INSPECTOR'S REPORT ON AN APPLICATION FOR A CERTIFICATE OF AUTHORISATION FOR A CLOSED LANDFILL

Application by **Kilkenny County Council** for a Certificate of Authorisation for a closed landfill at **Gowran, County Kildare**.

Certificate of Authorisation Register Number **H0235-01**.

Figure 3: Conceptual site model

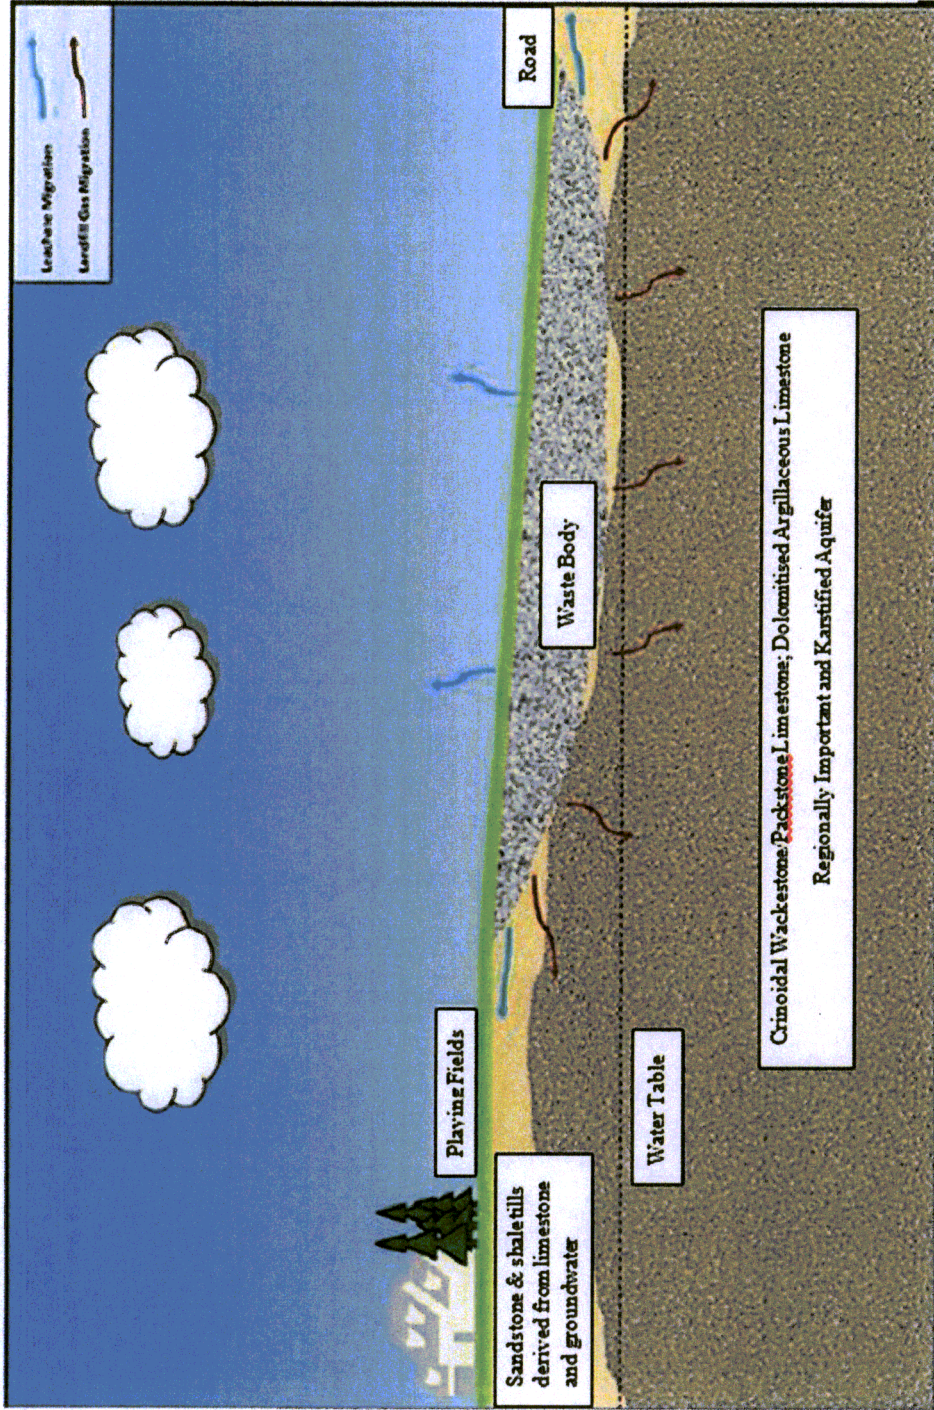
Conceptual site model	<p>The conceptual site model developed in 2014 and provided with the original application was updated following the Tier 3 Risk Assessment. It identified the following pollutant linkages:</p> <ul style="list-style-type: none"> • human health exposure via lateral and vertical migration of landfill gas; • migration of leachate into the underlying aquifer and discharge to users of groundwater for potable supply down hydraulic gradient of the site. The Gowran River (approximately 0.6 km to the south west of the site) may be a receptor for groundwater migrating through the site but this could not be definitively established given the karst nature of the bedrock; and • human health exposure pathway of off-site migration of landfill gas. <p>The conceptual site model is shown in Figure 3. The source, pathways and receptors can be described as follows:</p> <p>Source:</p> <ul style="list-style-type: none"> – Rainfall on the landfill will preferentially percolate through the cap and into the waste. – Leachate is generated in the waste albeit at low strength. – Gas is generated at the landfill. <p>Pathway:</p> <ul style="list-style-type: none"> – Leachate can potentially migrate through the gravels underlying the deeper sections of the waste into the underlying bedrock aquifer. – Leachate can migrate through the base of the landfill into the underlying aquifer beneath and discharge to the surface water body. – Gas migration can occur through the permeable cap and into silts, clays and karstified bedrock beneath the waste. – Gas migration beyond the site boundary through the foul sewer trench running along the site boundary with the houses to the east of the site. It is possible that the trench could act as a preferential pathway for gas migration, but this was not confirmed. <p>Receptors:</p> <ul style="list-style-type: none"> – Existing houses and users in close proximity of the site.

<ul style="list-style-type: none"> - The bedrock aquifer. - Downgradient abstraction wells and the Gowran River.
--	--
